# Concept Plan MP06\_0162 Modification 9 (MOD 9)

Response to RFI  
of 5 July 2024

Prepared for  
INSW

Figure 50 Visualisation showing the development envelope of the Approved Concept Plan (AECOM, July 2023)

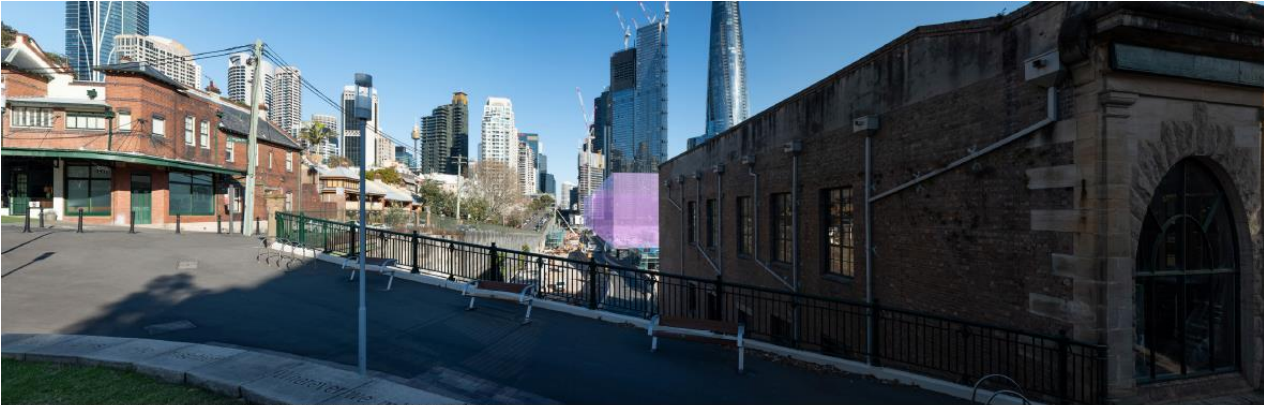
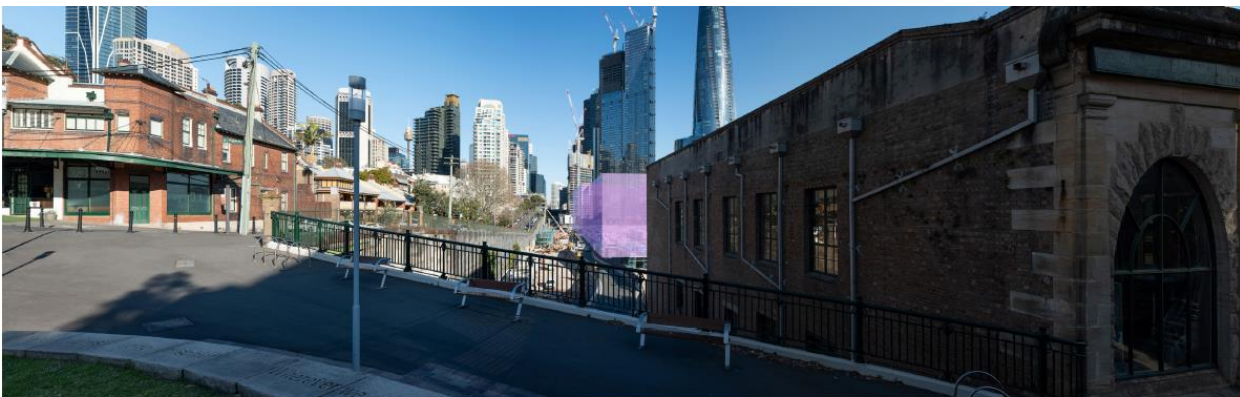
*Clarify the discrepancy in the landing point of the proposed Concept Plan envelope from the Hickson Road vantage point in the View and Visual Impact Assessment (VVIA) (refer to Figure 50 and 52)*

It is acknowledged that there is a discrepancy in the landing point of the proposed Concept Plan envelope from the Hickson Road vantage point when comparing the MOD 9 imagery to the extracts of the MOD 8 Barangaroo South View and Visual Impact Assessment.

The purpose of including an extract from the MOD 8 Barangaroo South View and Visual Impact Assessment from the Hickson Road vantage point was to assure DPHI that the RtS VVIA had been prepared in a manner consistent with the general methodology of MOD 8. The VVIA extract from MOD 8 was simply included for information regarding the methodology. The intent is not to provide a comparison of views.

It is noted that the MOD 9 RtS VVIA images at Figures 50 and 52 (see below) are taken from a location slightly setback from the edge of the bridge to include heritage items to either side within the frame. When considering Barangaroo South (i.e. MOD 8) these items are not particularly relevant as they are a considerable distance north of Barangaroo South. However, as Central Barangaroo extends north towards the vicinity of these items, they are more relevant to the visual analysis, and the slightly setback viewing position was therefore adopted to include them.
